April 15, 1983  
AEP:NRC:0637M

Donald C. Cook Nuclear Plant Unit No. 2  
Docket No. 50-316  
License No. DPR-74  
UNIT 2, CYCLE 4 SAFETY EVALUATION REPORT:  
RESPONSE REGARDING PLANT TRANSIENT METHODS

Response to the Plant Transient Analysis  
Issues Identified in the NRC Safety  
Evaluation Report (SER) for D. C. Cook  
Unit 2, Cycle 4

16-22-16.

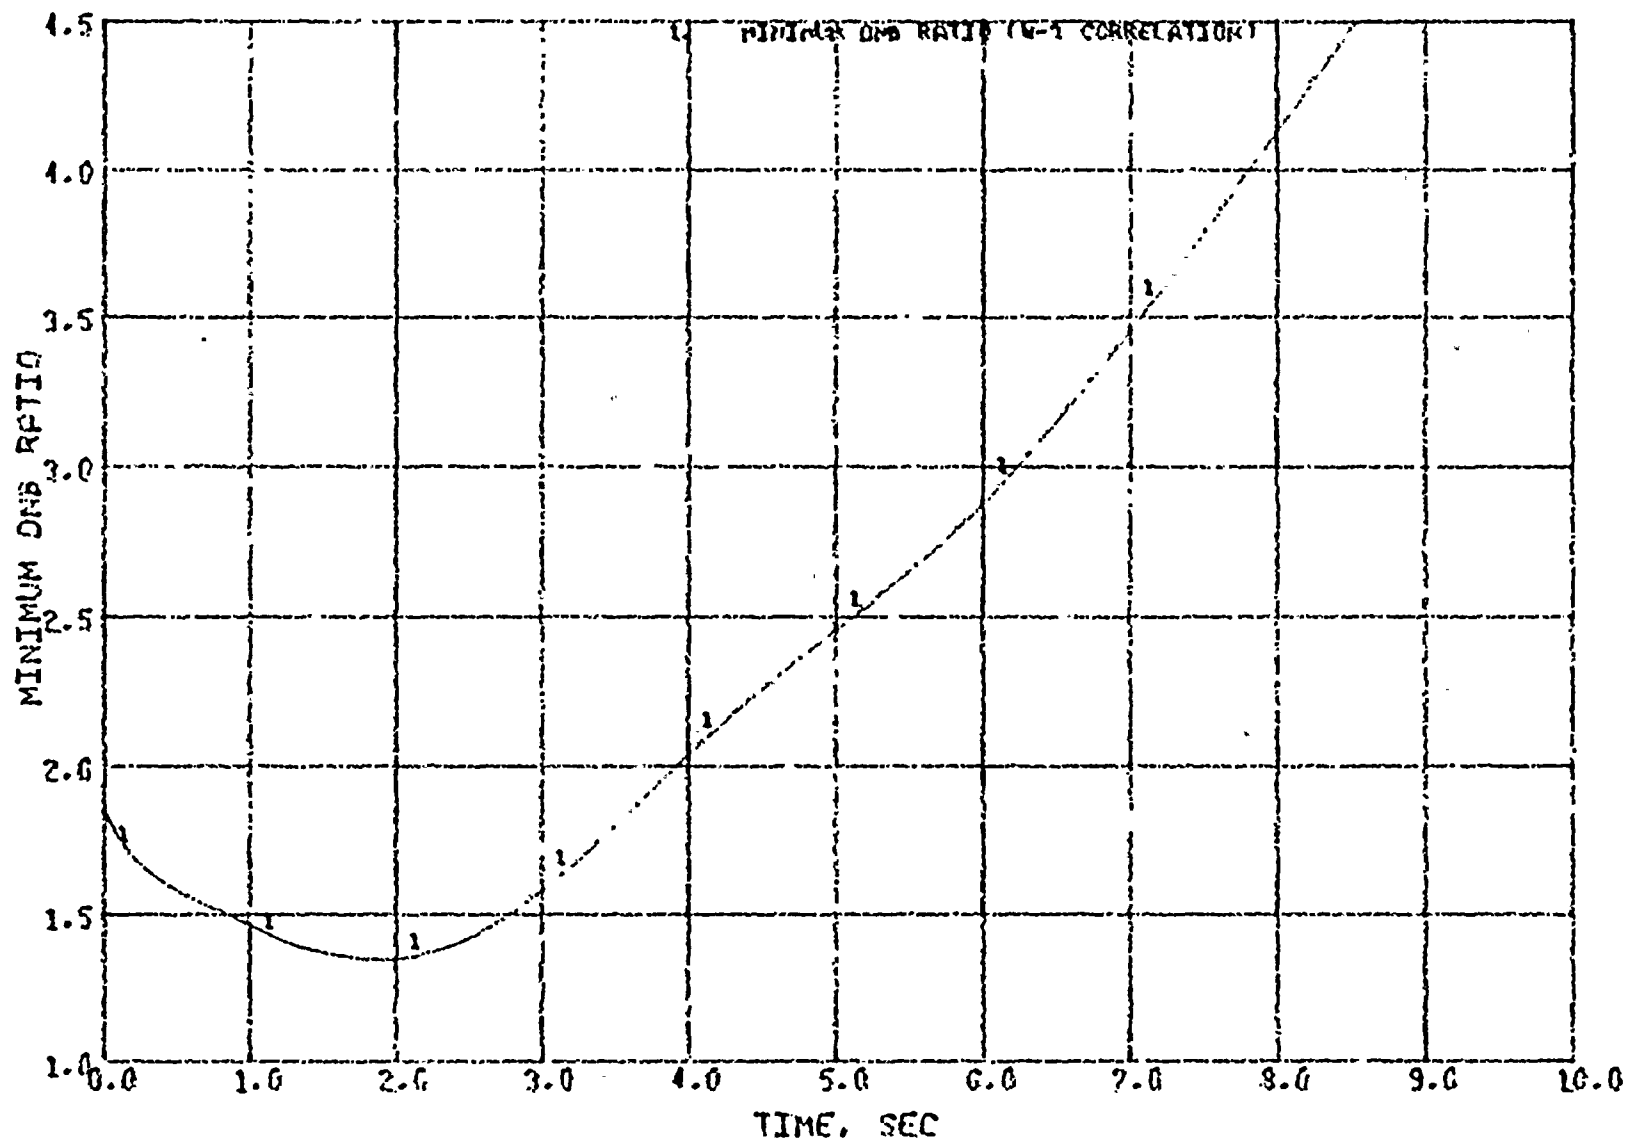
Item 1.2: Provide a confirmatory analysis which demonstrates that specified acceptable fuel design limits are not violated for the case of loss of offsite power. Justification for any delays assumed between reactor/turbine trip and loss of offsite power must be provided.

The requested simulation is attached. Inputs and methodology are identical to those used in Case 1, reported in XN-NF-82-32(P), Rev. 1, except that coastdown of the three remaining primary coolant pumps is assumed to occur simultaneously with the occurrence of the locked rotor. No delay is assumed between reactor trip and loss of offsite power. The calculated MDNBR is 1.34, only slightly degraded relative to the locked rotor case 1. Attached Figures 1-6 display the calculated system response.
